Planning Commission
CITY HALL COUNCIL CHAMBERS
AGENDA OF APRIL 8, 2025
7:00 PM

1. PPZ2025-0335: Panda Express, 32429 Cook Rd, PPN 07-00-003-102-104, -045, -046
Applicant: Phillip Meador, Heights Venture Architects, 5741 Legacy Dr, Suite 320, Plano, TX 74024. Owner: Cook Road Properties, LLC, 7670 Tyler Boulevard, Mentor, OH 44060. Proposal consists of constructing a new drive through restaurant. Property zoned B-3 Highway Commercial District.
2. PPZ2024-0319 City Limits, 39462 Center Ridge Rd, PPN 07-00-046-101-006
Owner: Stephen Joseph, 36821 Sugar Ridge Rd, North Ridgeville, OH 44039. Proposal consists of building and site improvements for restaurant and lounge. Property is zoned B-3 Highway Commercial District.

**NORTH RIDGEVILLE PLANNING COMMISSION
MINUTES OF REGULAR MEETING
TUESDAY, MARCH 11, 2025**

Figure 3 - Potential Circulation Alternative

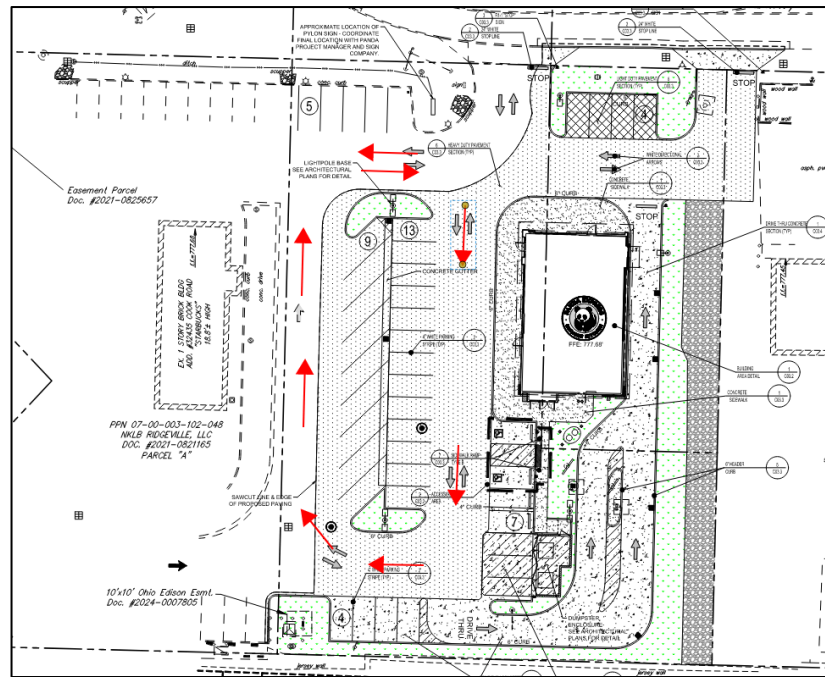
The provided site plan shows two-way traffic on all internal roadways within the Panda Express site; this can cause temporary internal roadway gridlock, leading to blocked driveway throats and spillbacks onto Cook Rd. In conjunction with the access modifications mentioned above, Woolpert recommends consideration of a one-way circulation pattern within the site to streamline traffic flow, as shown in **Figure 3**. As part of this consideration, the straight parking shown across from the west side of the proposed building should be converted to angled parking in line with the one-way circulatory movement.

- Consider modifying the project site access at the west drive to right-in, right-out only, or convert the project site access to west entry only, and east exit only to address driveway spacing concerns.
- Consider modifications to the proposed circulation plan to provide one way circulation as shown in **Figure 3**, to avoid potential internal gridlock during high demand periods.
